Project	IEEE 802.16 Broadband Wireless Access Working Group < http://ieee802.org/16 >
Title	MSS's buffer capability negotiation for DL H-ARQ operation
Date Submitted	2004-11-02
Source(s)	kang-gyuLee, yunsungKim, sajinKim, leekg@samsung.com jae-hwanChang, yunsangPark, tseliot@samsung.com Jaehee Cho, Geunhwi Lim, sj.kim@samsung.com jaehwan.chang@samsung.com yunsang.park@samsung.com
Re:	This contribution is for call for contribution about IEEE P802.16e/D5-2004
Abstract	This contribution proposes the MSS buffer capability information for H-ARQ.
Purpose	
Notice	This document has been prepared to assist IEEE 802.16. It is offered as a basis for discussion and is not binding on the contributing individual(s) or organization(s). The material in this document is subject to change in form and content after further study. The contributor(s) reserve(s) the right to add, amend or withdraw material contained herein.

MSS's HARQ buffer capability negotiation for DL H-ARQ operation

Figure 1. H-ARQ procedure with MAC buffer capability signaling

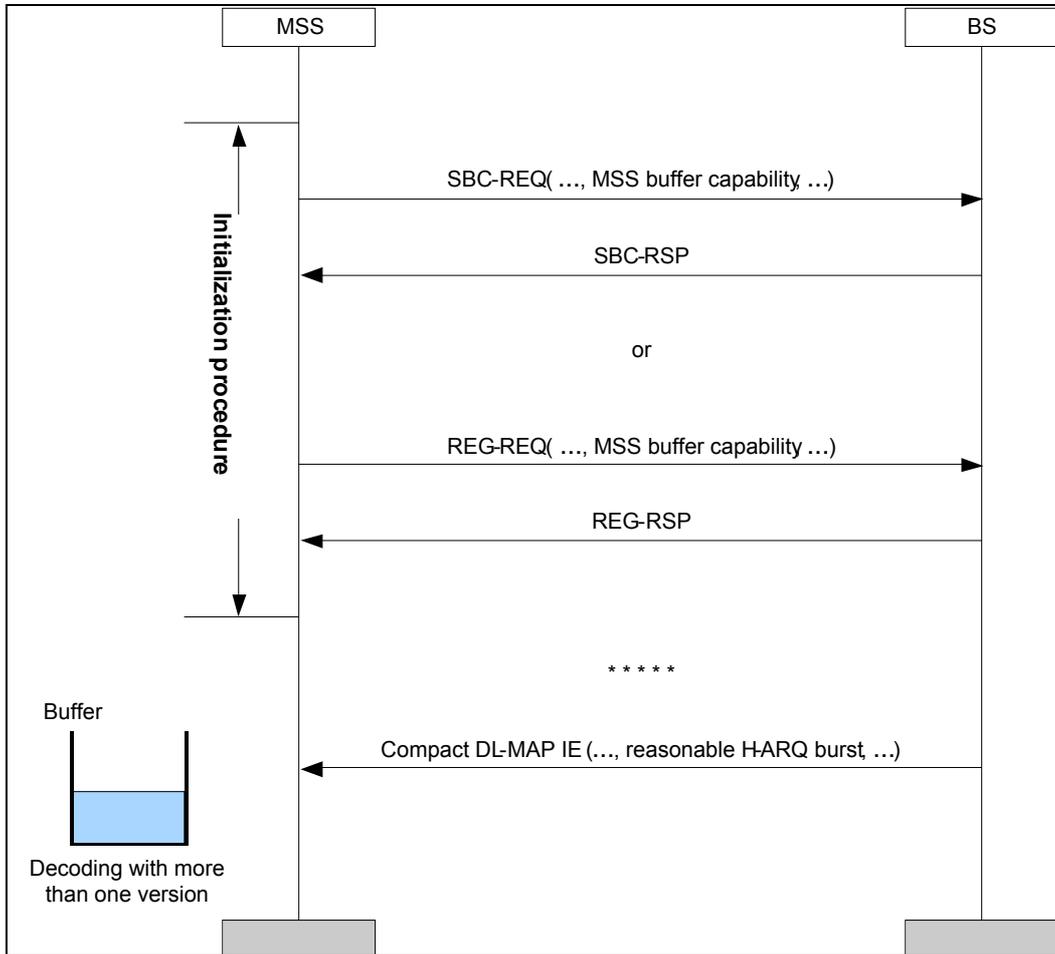
Add the parameter 'MSS buffer capability' into (M)SS Capability encodings which may be included in SBC-REQ/SBC-RSP or REG-REQ/REG-RSP messages. The H-ARQ enabled MSS informs the BS of its buffer capability during initialization procedure as follows.
